In the Drawings

REMARKS***In the Drawings***

CONCLUSION

FIG. 1

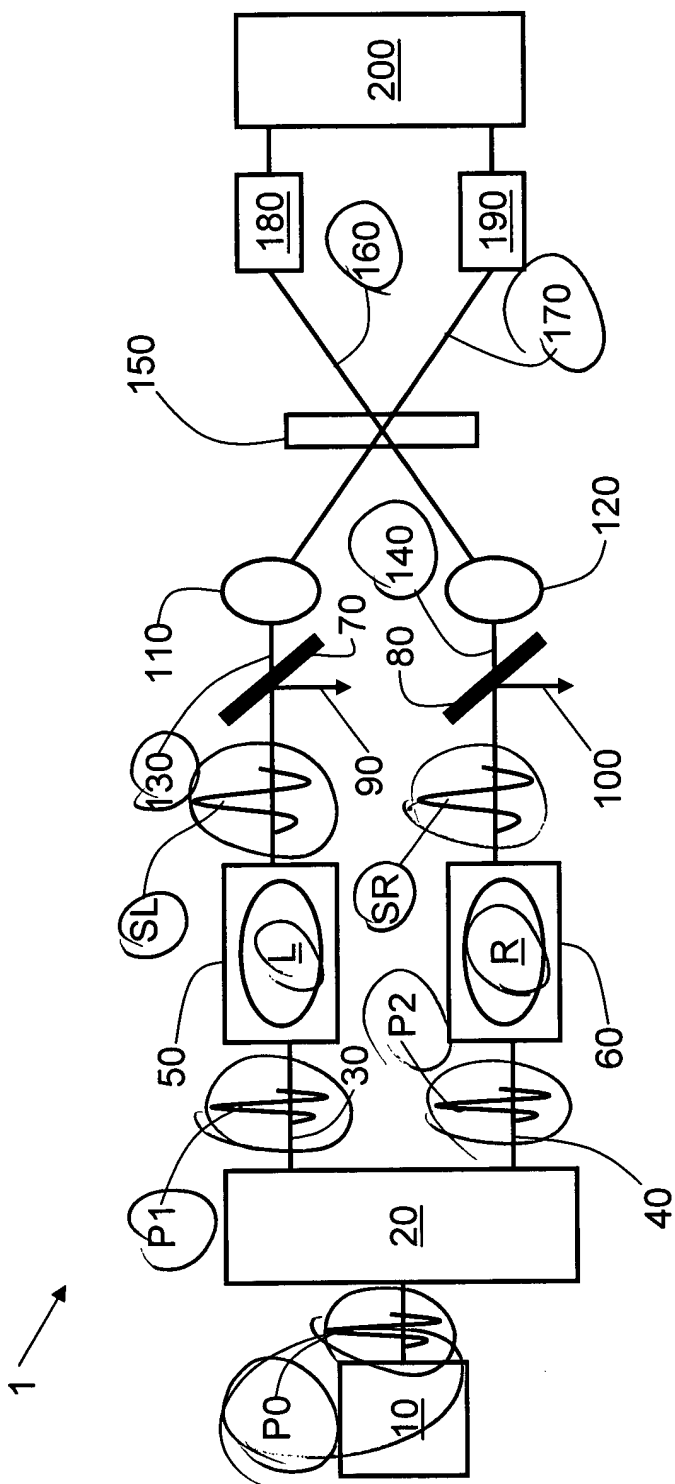
FIGS. 1 through 4 have been amended to include more details of the apparatus as described in the specification and in the claims. In particular, FIG. 1 has been amended to include optical pulses P0, P1 and P2 and Stokes light pulses SL and SR. Also, the atomic ensembles L and R are now shown more clearly as being contained in cells 50 and 60, respectively. Similar changes have been made to FIGS. 2-4, along with the addition of electrical signals S280 and S281 (FIG. 2), and S490 (FIG. 4).
